**SUBJECT: ZF FRIEDRICHSHAFEN AG, ("ZF") SOFTWARE UPDATE
CAMPAIGN DUE TO CELL PHONE AND RADIO INTERFERENCE**

Ref.: ZF NHTSA #06E100
MCI NHTSA #08V-603
TRANSPORT CANADA # 08-404
MCI Service Bulletin 308

Service Bulletin No. 308

MODEL D / E / J Series Coaches	TYPE Field Change Program	SECTION/GROUP 13 – Transmission	DATE Dec.16, 2008
SUBJECT ZF SOFTWARE UPDATE CAMPAIGN FOR CELL PHONE & RADIO INTERFERENCE			
CONDITIONS

Figure 1. NO cellular phone decal.

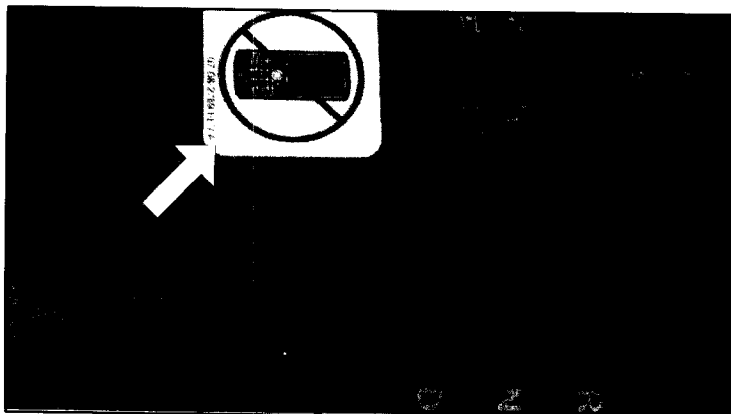
MCI strongly encourages owners of (1) D model coaches equipped with a ZF transmission between the range of, and including, unit numbers 54360 to 56558, and (2) E / J model coaches equipped with a ZF transmission between the range of, and including, unit numbers 61564 to 63068, to contact their MCI Product Support Specialists (PSS) or their local MCI Service Center at the earliest opportunity to schedule an appointment to have the neutral safety switch removed, if required. Upon removal of the neutral safety switch, MCI will download the new ZF software program and apply a decal beside the touch pad shift selector warning that cellular phones, PDAs, radios capable of transmitting, antennas or power supplies must be kept a minimum of 20 inches/50 cm away from the touch pad shift selector. (AS Tronic manual – 1337.758101)

MCI strongly encourages owners of (1) D model coaches equipped with a ZF transmission between the range of, and including, 56559 to 58713 and (2) E / J model coaches equipped with a ZF transmission between the range of, and including, unit numbers 63069 to 64987 contact their local authorized ZF Service Facility or MCI Service Center to download the new ZF software program and have a decal applied beside the touch pad shift selector warning that cellular phones, PDAs, radios capable of transmitting, antennas or power supplies must be kept a minimum of 20 inches/50 cm away from the touch pad shift selector. (AS Tronic manual – 1337.758101)

Qty.	New P/N	Description
1	07-08-2789	Decal, No Cell Phone

The only part required for this change is the 07-08-2789 Decal.
